Issued: June 10, 2019

**ADDENDUM NO. 3**  
**SPRING VALLEY LAKE ADA AND OVERLAY PROJECTS**  
**WORK ORDER: H14932 & H15010**  
**AREA: Spring Valley Lake**

**SPRING VALLEY LAKE ADA RAMPS AND VARIOUS ROADS OVERLAY PROJECT**

**Catch Basin 1**  
**12844 Spring Valley Parkway**

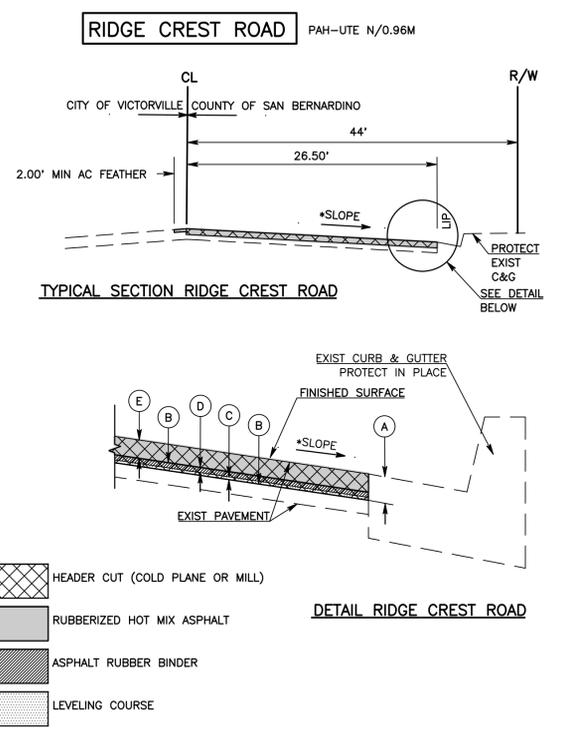
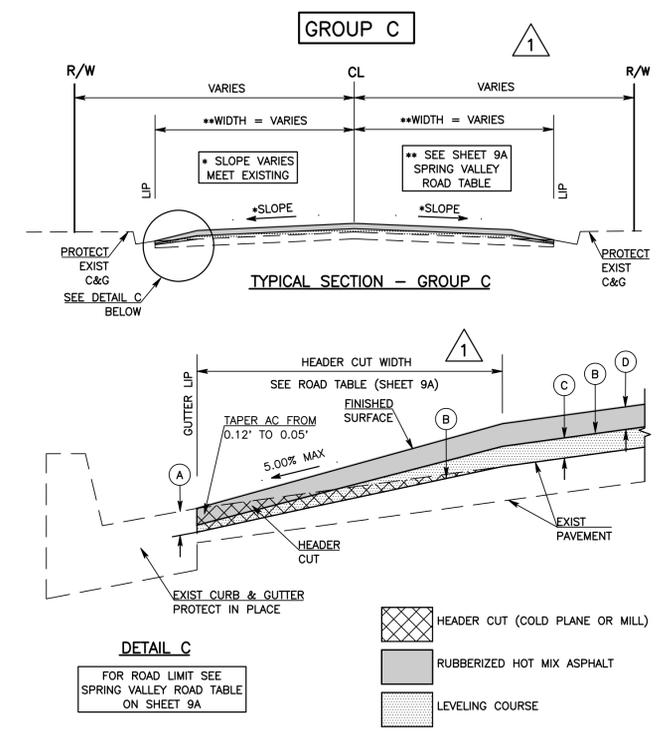
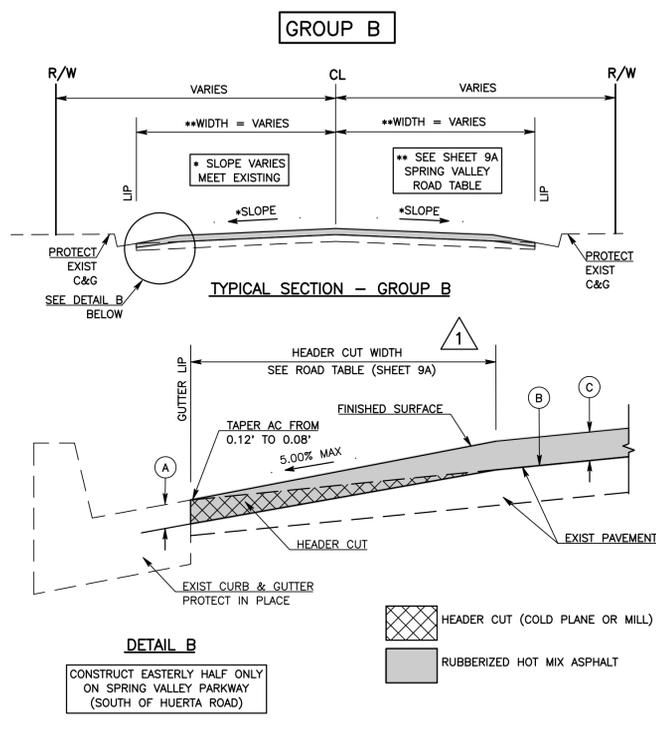
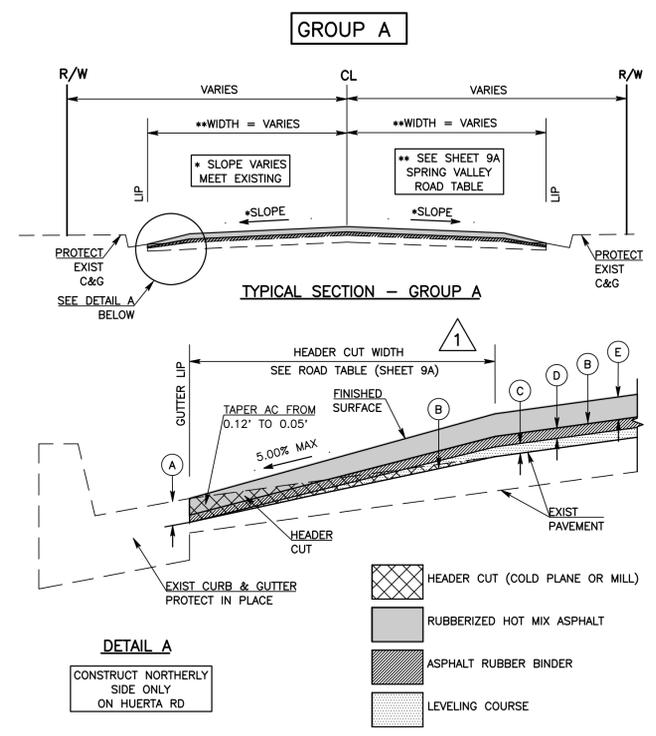
At locations along Spring Valley Parkway as identified by the Engineer, the damaged portion of four (4) existing Catch Basins require minor repair, restoration and reconstruction, as designated or directed by the Engineer. The repairs and restoration shall conform to County Standards. 206 (Modified) and 206a.

Contractor shall perform repairs and restoration with extra care for the existing four (4) Catch Basins at the following locations:

Photos of all four (4) damaged Catch Basins are attached somewhere in these Special Provisions for visual and information purposes only. The Contractor shall site visit, identify, evaluate and assess the damaged portion of the existing catch basins prior to submitting his

Prior to any repairs, the Contractor shall provide a repair and restoration plan for each damaged section of the Catch Basins for the Engineer's approval.

J.L. REF. W.O. NO. H14932 H15010  
NONE  
PLAN SCALE NONE  
SHT. NO. 8B  
TOT. SHT'S. 9

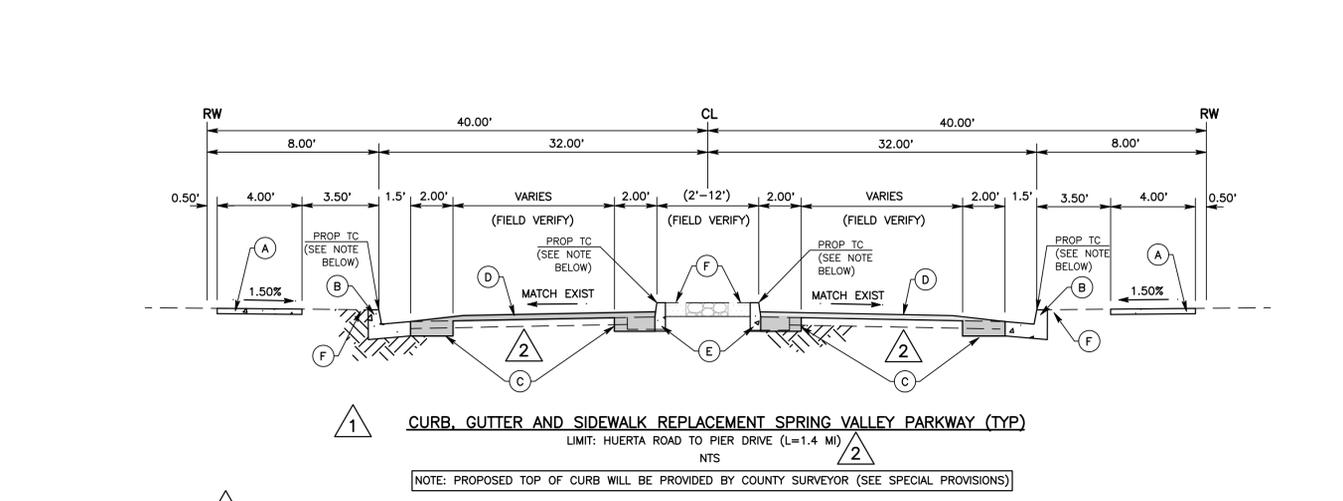
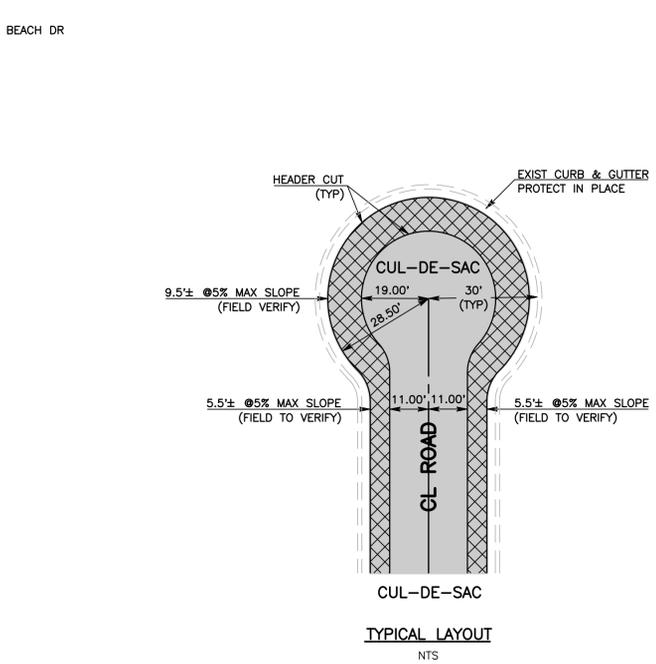
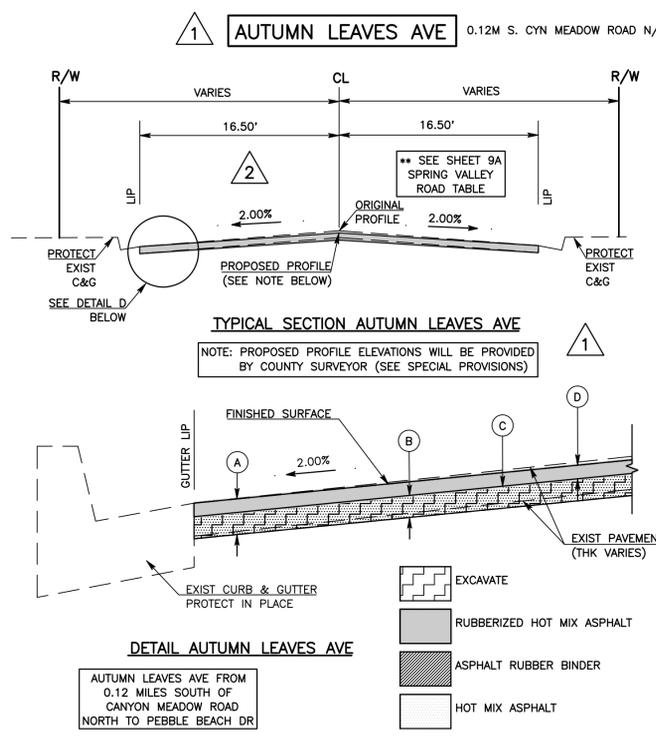
1. Replace Sheet No. 8 by Sheet 8B.
